Subject: AP1000 Response to Requests for Additional Information (SRP15.3)

Response to Requests for Additional Information on SRP Section 15.3

RAI Response Number: RAI-SRP15.3-RSAC-01
Revision: 0

Table 1
Potential Leak Paths and Characteristics for AP1000

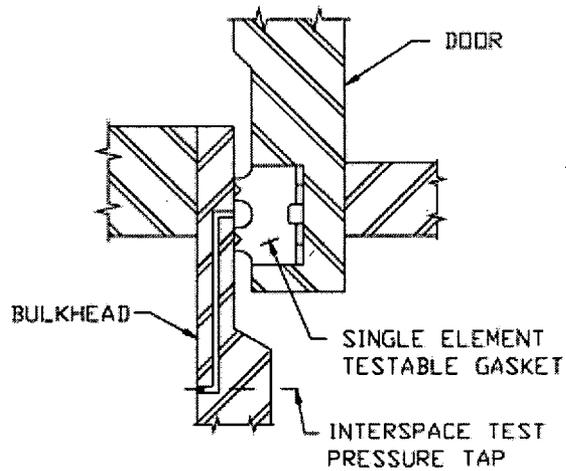
B) No geometrical information about the leak paths is provided other than a path height of 0.155 cm, crack size of 4.45 cm, and 1.75 inch crack depth. The staff believes that many of the hypothesized leak paths would be better approximated as orifices rather than passageways. The staff also finds that no sufficient geometrical information is provided to evaluate if leak paths are orifices, capillaries or straight channels. Treated as orifices, there would be no "walls" for the hypothesized inertial impaction of aerosols as you assumed. Please describe geometrical information about the leak paths in more detail with justification.

B) A description of potential containment leak pathways, their geometries and their discharge locations is provided on page 9 of APP-GW-GLN-122. The list of potential leak paths from that discussion is provided in Table 1. The most likely containment leakage occurs through multiple parallel pathways at penetrations and hatch seals (Figures 1 and 2 from DCD Chapter 3.8.2), which discharge to the auxiliary building and would be subjected to additional deposition before being released to the environment. Through-wall cracks in multi-pass butt welds in the containment shell are more unlikely and discharge to the passive containment cooling system (PCS) annulus.

To be conservative, Westinghouse models the leakage from the containment as a single round hole through the containment shell to the PCS annulus. The flow path is considered to be a smooth capillary, which is conservative as outlined below. The diameter of the hole, 1.55 mm, is determined by the design leak rate, which is the maximum diameter for postulated leak path. The length of the hole is determined by the straight-through thickness of the containment shell, which is 1.75 inches. The single hole modeled in AP1000 containment shell has a length to diameter ratio (L/D) that is, at a minimum, 28.6. According to Sutter (Reference 1) an orifice is an opening in which the length is smaller than or equal to the diameter of the opening. It is inappropriate to treat the hole in the AP1000 containment shell as an orifice.
